STAFF REPORT & DECISION *for* PRELIMINARY SHORT PLAT

LAND USE ACTION: Administrative Approval of a 2-lot Preliminary Short Subdivision

PROJECT NAME/NUMBER: Eldridge Short Plat; PL13-061

ELDRIDGE SHORT PLAT
 NE 1/4, SE 1/4 OF SEC. 30, TWP. 34 N., RING. 4 E., W.M.
 CITY OF MOUNT VERNON,
 SHAGHT COUNTY, WASHINGTON

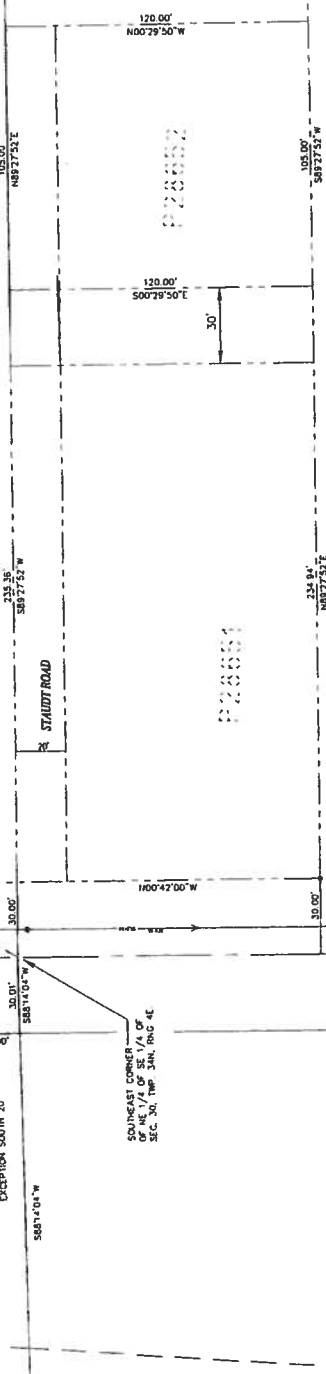
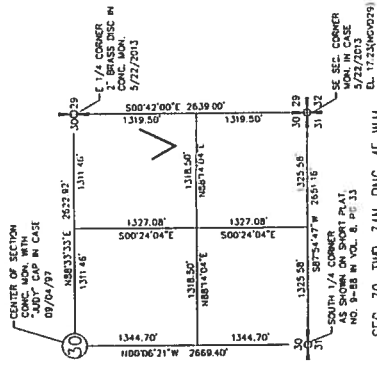
Engineering staff has reviewed the Short Plat application dated June 27, 2013 and the Short Plat map site plan and has the following comments:

- Driveway entrances are required to be installed per City Code at the time of development.
- Traffic concurrency review is required.
- According to city records there is a 12" storm stub in the property as well as an existing 8" sewer stub. It is the responsibility of the developer to verify the existence of utilities.
- Any new or redevelopment will require a stormwater analysis prepared by a licensed civil engineer addressing stormwater quantity and quality in accordance with City of Mount Vernon Engineering Standards Chapters 2 & 5 and MVMC 13.00 and 2005 Washington State Department of Ecology Stormwater Management Manual for Western Washington.
- Utility easements may become necessary during Engineering Plan Review.

- The applicant shall provide a dumpster area in compliance with MVMC 17.85. for commercial development.
- This project shall comply with all City standards and codes.
